# **Grandstream Networks, Inc.**

## **Request for Class II Permissive Change**

FCC ID: **YZZHT802**

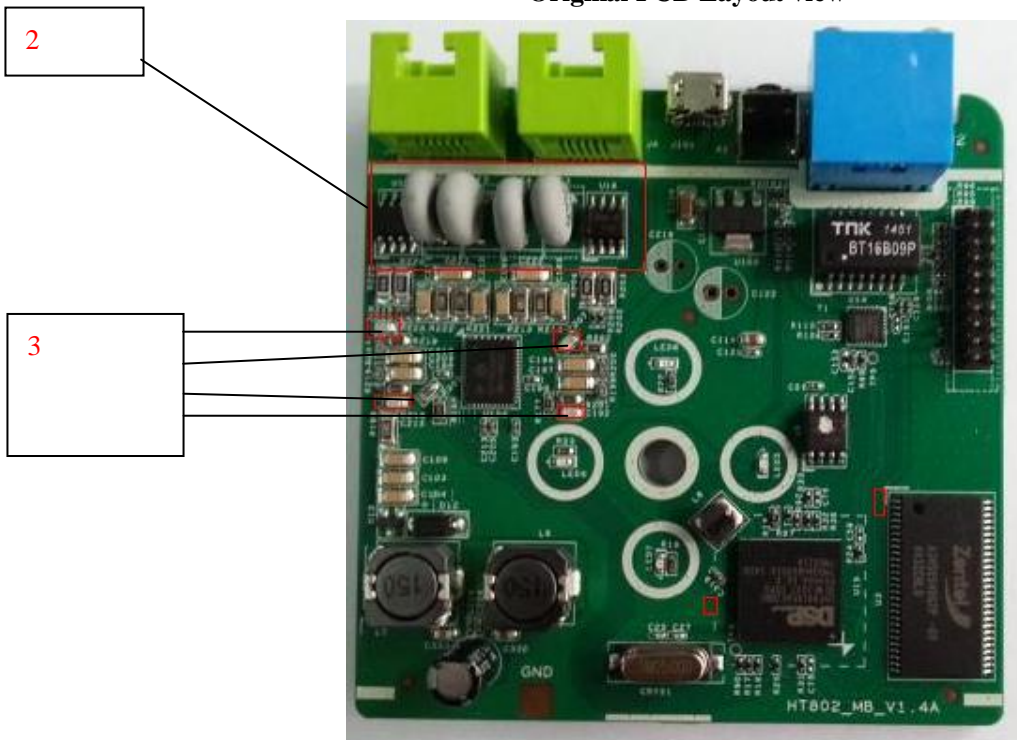
1. Upgrade hardware version from HT802 V1.3 to HT802 V1.5;
2. Add four PTCs for over current protect;
3. Add four capacitors to remove Audio noise;
4. Change the PCB layout(see the figure below);
5. add two power adapter (Model: NBS05B050100VU/F06US0500100A) and has the same electrical specification with original power adapter
